Re: Comments of the American Petroleum Institute regarding the Federal Land Managers' Air Quality Related Values Workgroup (FLAG) Revised Phase I Report; 73 Fed. Reg. 39039 (July 8, 2008)

Technical Comments Regarding the Federal Land Managers' Air Quality Related
Values Workgroup (FLAG) Phase I Report – Revised
(06/27/08 Draft)

Figure 1. Cumulative Frequency Distribution for Bridger Class I Areas NO₃ Concentrations Modeled versus Monitored 1988-2005.

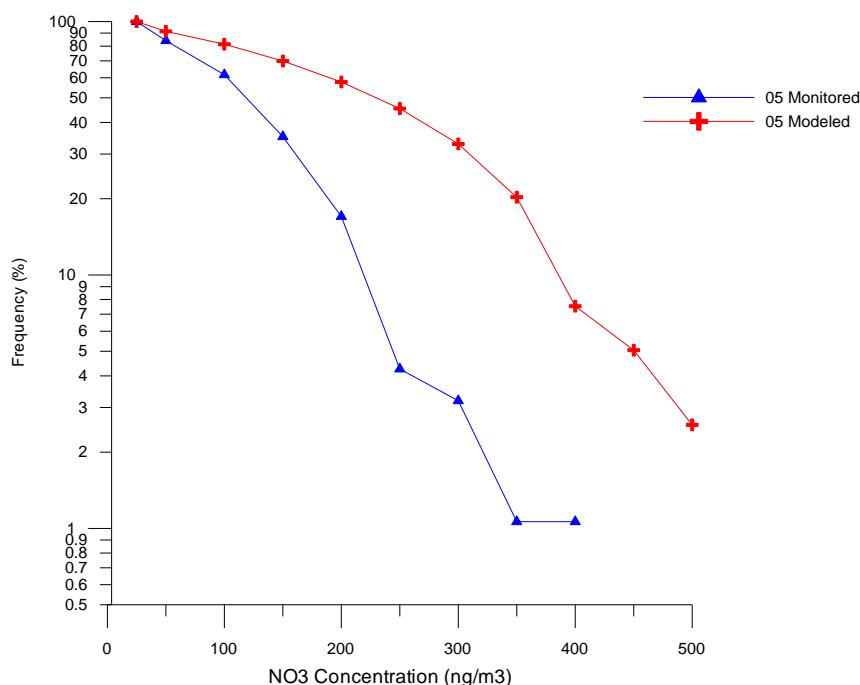
A limited evaluation of CALPUFF accuracy using the IWAQM approach was conducted in response to the BLM Moxa Arch EIS⁶. This evaluation focused on a limited evaluation of secondary NO₃ for each day and the reported receptor that had the highest visibility impacts for the 2005 actual inventory. The maximum **predicted** NO₃ concentration as a result of oil and gas operation in 2005 was 5.3 µg/m³. The 2005 Bridger **monitored** NO₃ concentration data were obtained from the IMPROVE web site and the maximum measured concentration was 0.56 µg/m³. In actuality, this was the lowest maximum NO₃ concentration at the Bridger monitoring site over the period of 1988 through 2005. This provides a strong indication that CALPUFF is substantially over predicting NO₃ concentrations at the Bridger Class I Area.

There are minor limitations to this analysis such as the lack of availability of 2005 meteorological data which therefore required the use of 2001 meteorology. As a result, it was not possible to compare specific days of model output with days that monitoring data were collected. Changes in meteorology alone are not likely to cause such a large model over prediction. A second minor limitation is that since the IMPROVE data are only collected every 3 days, high NO₃ may have occurred on days when sampling was not collected. This possibility was examined by reviewing NO₃ concentrations over the period of record (1998-2005) and the maximum NO₃ concentration was 0.82 µg/m³ (in 2002). Clearly, as a result of this comparison there is a very strong indication that CALPUFF is substantially over predicting measured NO₃ concentrations when using IWAQM methodology. Figure 1 presents the observed and CALPUFF predicted frequency distribution. As indicated by this figure, CALPUFF is not replicating the IMPROVE monitoring data with any degree of certainty.

Figure 4. Comparison of CALPUFF Chemistry Modules

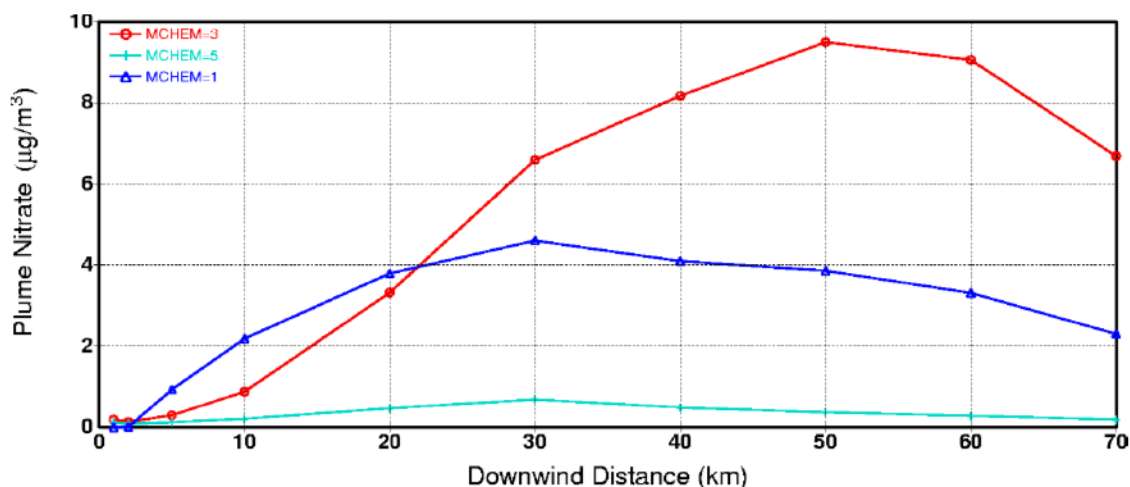
API has recently conducted an evaluation of the EPA CALPUFF model and, based on that review, it was concluded that there were errors in formulation of the chemistry modules of the model⁹. As part of the API study, a new version of CALPUFF has been developed which includes both corrections to errors in the existing gas-phase chemistry module, as well as incorporation of new science modules for inorganic and organic aerosols and aqueous-phase chemistry.

The changes to the chemistry algorithms in the CALPUFF model were revised to be more consistent with the state of science chemical mechanisms available in the photochemical grid models CAMx and CMAQ. Figure 4 presents a comparison of nitrate predictions from the new and previous algorithms in CALPUFF. As indicated in this figure, when the model is run using current state of science chemical formulations (consistent with CAMx and CMAQ), substantially lower NO_3 concentrations are predicted and theoretically should be more consistent with monitoring data.

Figure 5. Comparisons of Predicted NO_3 Concentrations for Various NH_3 Levels As a Function of Distance.

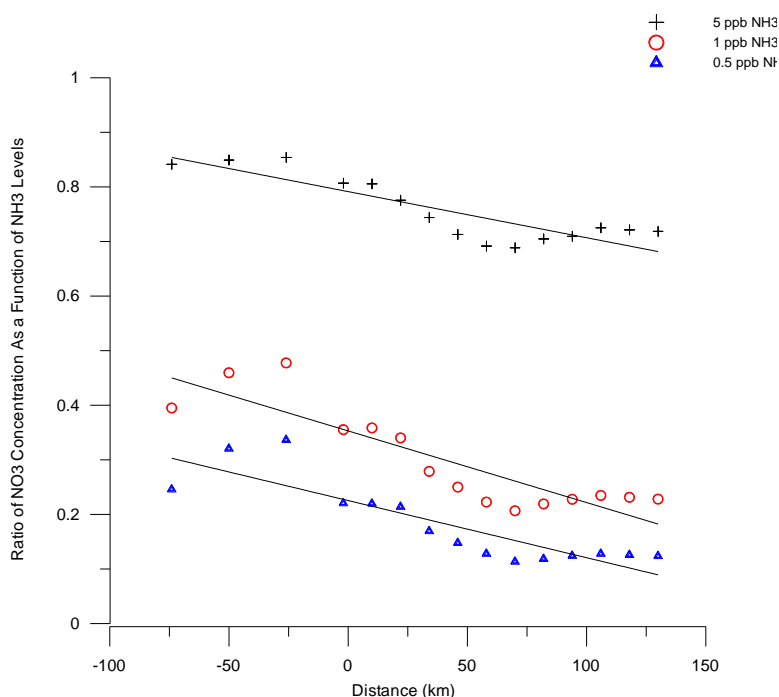
As indicated by this figure, there was approximately a 60 percent difference in predicted NO_3 concentrations by changing the background concentration from 1 ppb to 0.5 ppb. The application of how NH_3 concentrations are used in CALPUFF is very conservative because the model assumes that the NH_3 concentration is uniform between the ground and plume height. In reality, this assumption is not likely to be true and NH_3 concentrations at plume height will be less than those at ground level.

Recent monitoring in Wyoming and the Four Corners region indicate that the use of 1 ppb NH₃ for modeling is inappropriate. It is recommended that a more recent analysis of background NH₃ for

the intermountain west be conducted. Consideration should be given to back calculating NH_3 based on CASNet measurements.

Figure 9. Measured Wind Rose from Jonah and Lander Hunt Field and CALMET/MM5 Predicted Wind Rose

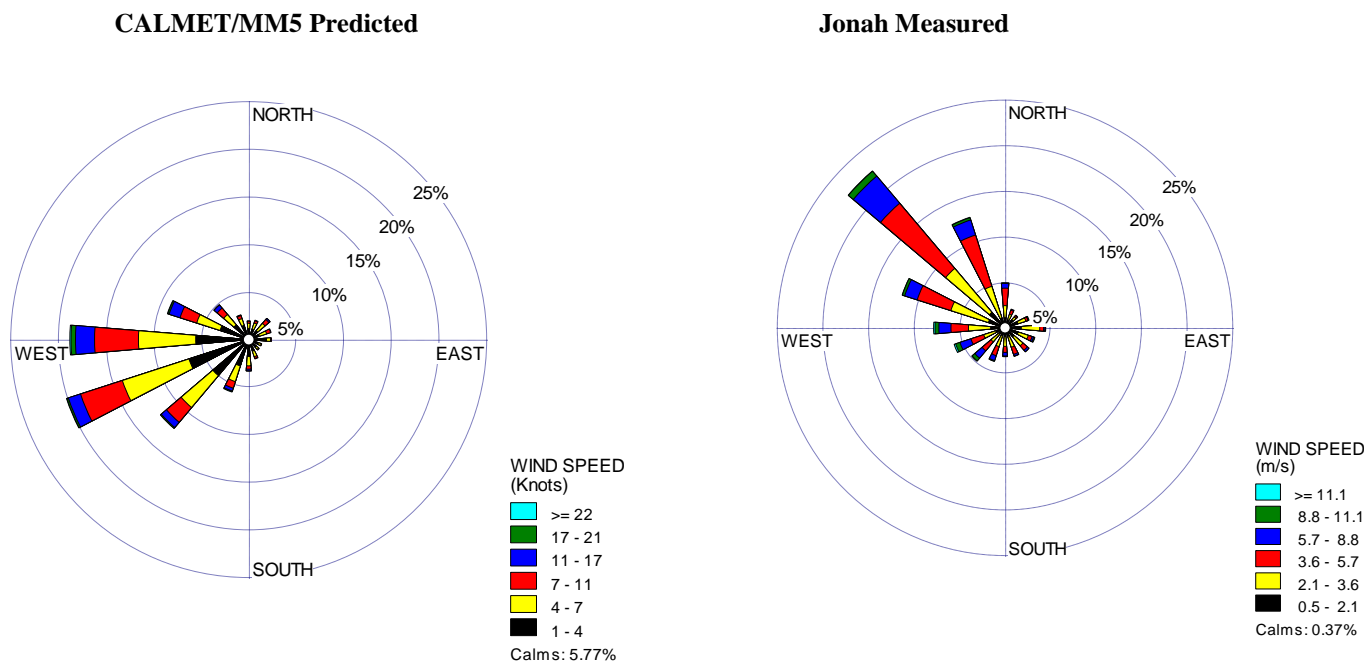
Figure 9 presents a comparison of 12 kilometer MM5 results with the data collected at the Jonah meteorological tower.

As indicated in these figures, when MM5/CALMET was run on a 12 kilometer grid, the models could not replicate the measured Jonah wind speed and direction data. In fact, the modeled wind rose appears to be more similar to the meteorological data measured at the Lander Hunt site that is located on the eastern side of the Wind River Mountains. One possible explanation for this poor performance in MM5 is that MM5 does not appear to include the influence of the Wind River Mountain Range and may be a result of averaging terrain over a 12 kilometer grid cell.

Figure 10. Comparison of 4-Kilometer MM5 Model Results to Jonah Meteorological Data

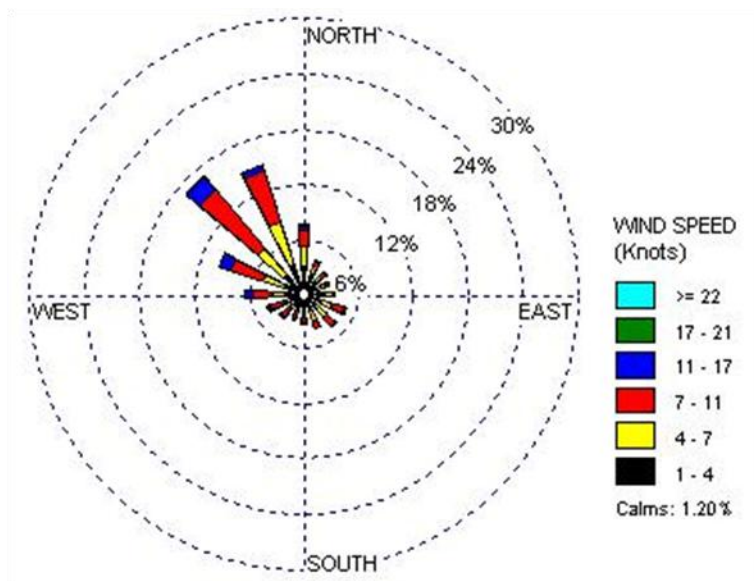
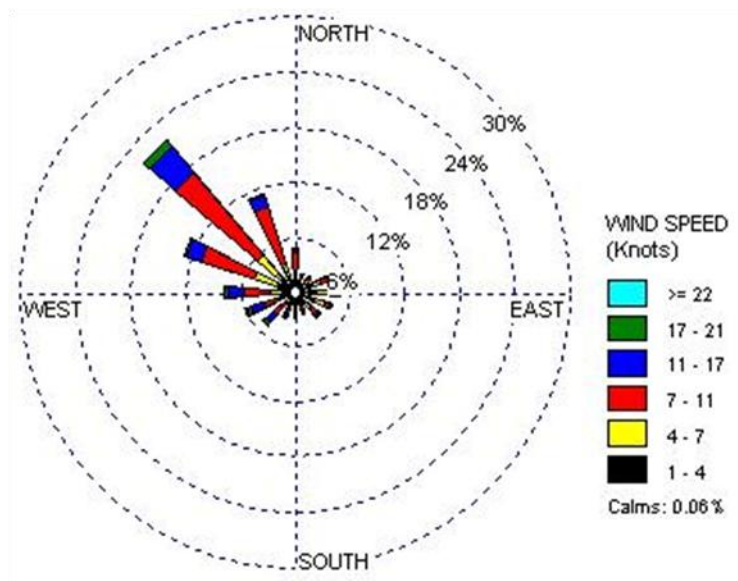
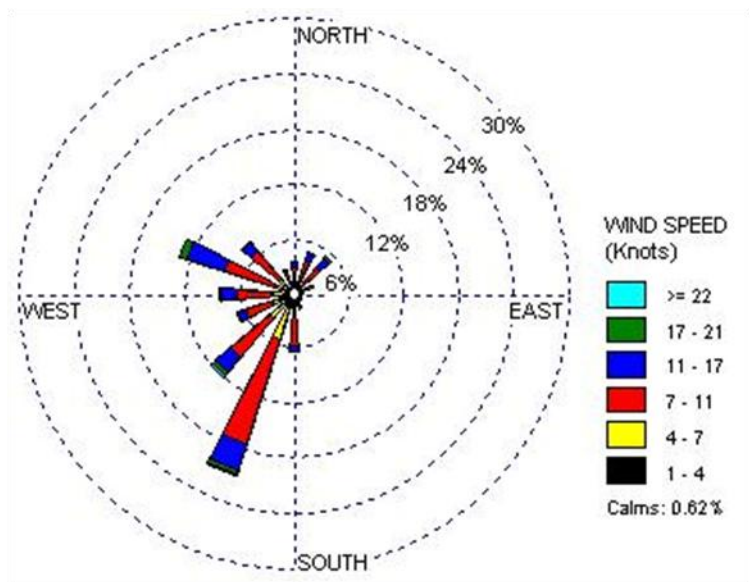
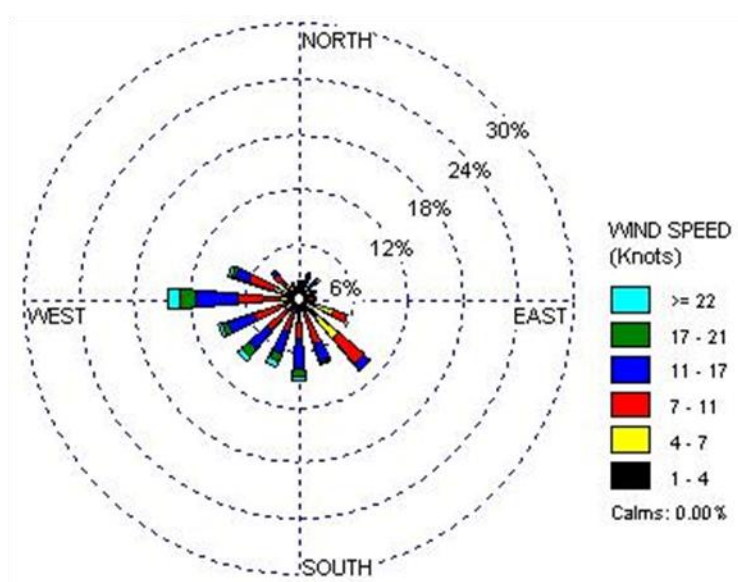
Figure 10 presents a comparison of annual wind roses for the Jonah tower and 4 kilometer MM5 modeling. Unlike the 36 and 12 kilometer modeling results, the use of this size grid does replicate the observed meteorological data collected at Jonah. However, additional, analyses of the Wamsutter meteorological tower (installed in 2005) indicates that even with the use of this small grid size, MM5 cannot replicate the measured data.

If MM5 modeling results are supplemented with local meteorological data through CALMET, unrealistic and discontinuous wind fields can be developed.

For southwestern Wyoming, this analysis indicates that MM5 is not producing accurate wind fields. It is recommended that more emphasis be given to developing one year of accurate meteorological data for model input rather than using multiple years of data that do not accurately represent flow in the region. The decision on the use of the meteorological data to be used in an AQRV analysis should be a case-by-case decision rather than prescribing the use of 3-5 years of prognostic meteorological modeling results as input to an air quality model.

Figure 11. Comparison of Lengths of the Longest Lines for 35 National Parks and the Estimated Sight Path within these Parks²⁰

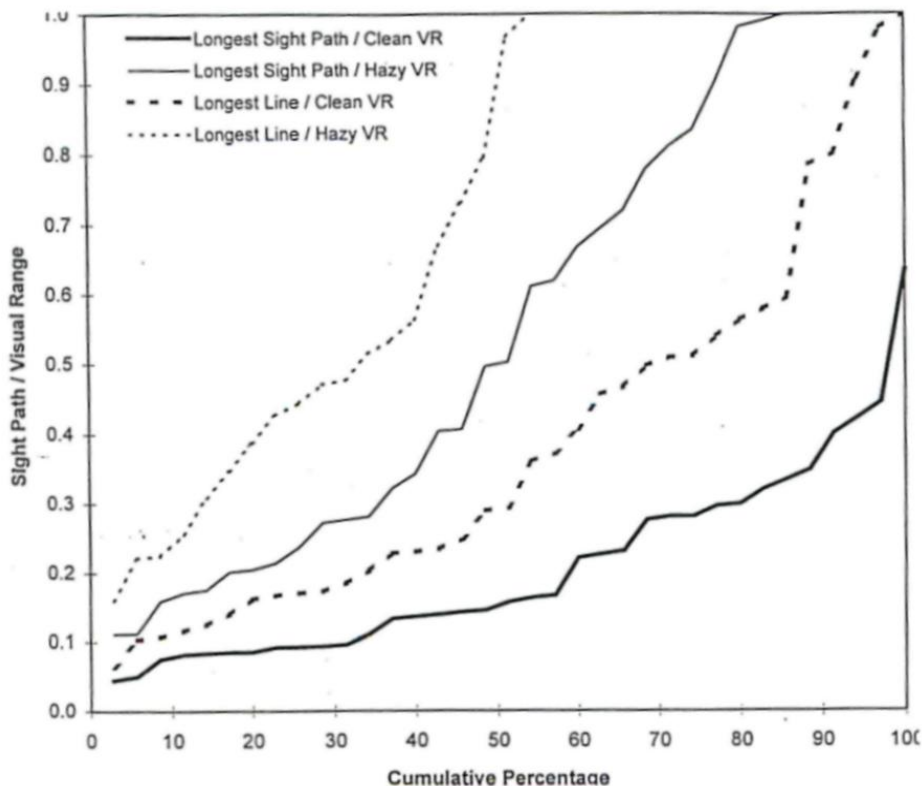
It is important to place the assumptions used by Pitchford and Malm into practical perspective. Figure 11 presents a comparison of the longest sight paths that can be drawn within 35 Class I Areas as well as the estimated lengths of the longest visual range.

The visual ranges were calculated from the average light extinction coefficient for the 20 percent of the days that were the least impaired (clean) as well as the 20 percent of the days that were the most impaired (hazy). A point on a line indicates the percentage of the parks that have a ratio equal to or smaller than the value at that point. Most ratios are less than 1 and therefore sight paths are typically shorter than the visual range and contrary to the assumptions used in the development of the deciview index. This indicates that for a vast number of Class I Areas, the basic assumption of the deciview calculation has not been met. Thus, assuming that the sight path is equal to the visual range simply adds a layer of unnecessary additional conservatism to

Figure 15. Sensitivity of model-calculated ozone to changes in NO_x mixing ratio. The red line corresponds to a high NO_x concentration (10 ppbv), the blue line to 2 ppbv of NO_x, and the dashed blue line to low NO_x (1 ppbv).

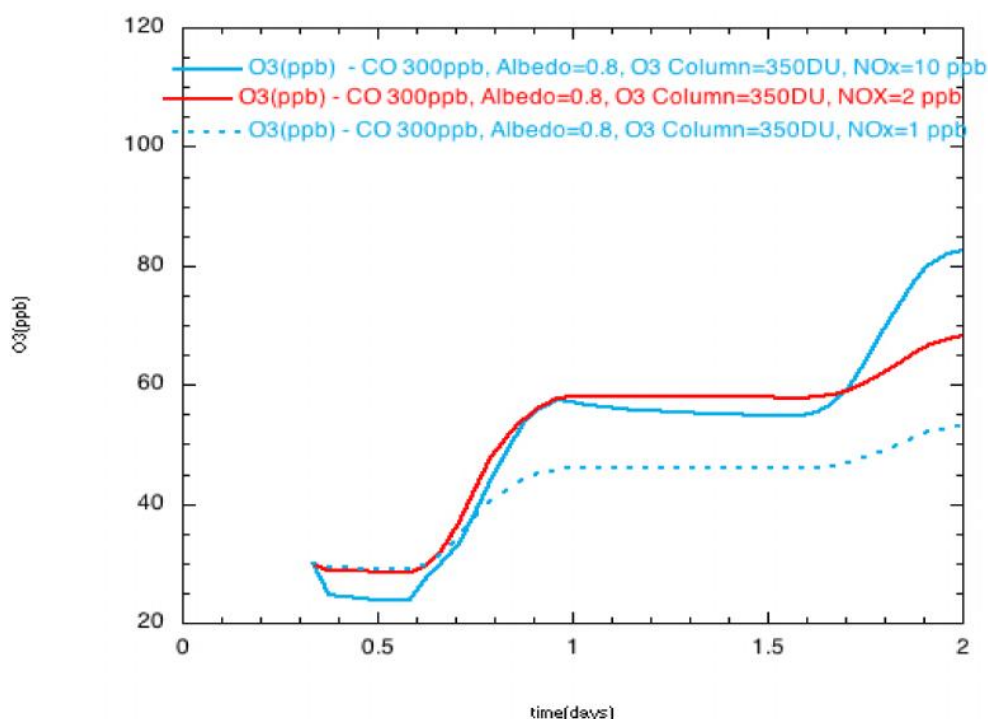
The first issue with this statement is that the FLMs provide no reference on the specified levels. Thus, it is not possible to verify that this information is applicable. The following figure is part of

a photochemical box modeling analysis that was conducted for southwestern Wyoming²². The input to the model was ambient air concentrations that were measured during periods of high ozone. As indicated in Figure 15, reducing ambient NO_x concentrations results in higher ozone concentrations. It is inappropriate for the FLM to predetermine if an area is VOC or NO_x limited. Such a decision must be based on site-specific analysis of air quality emissions or concentrations in the area.
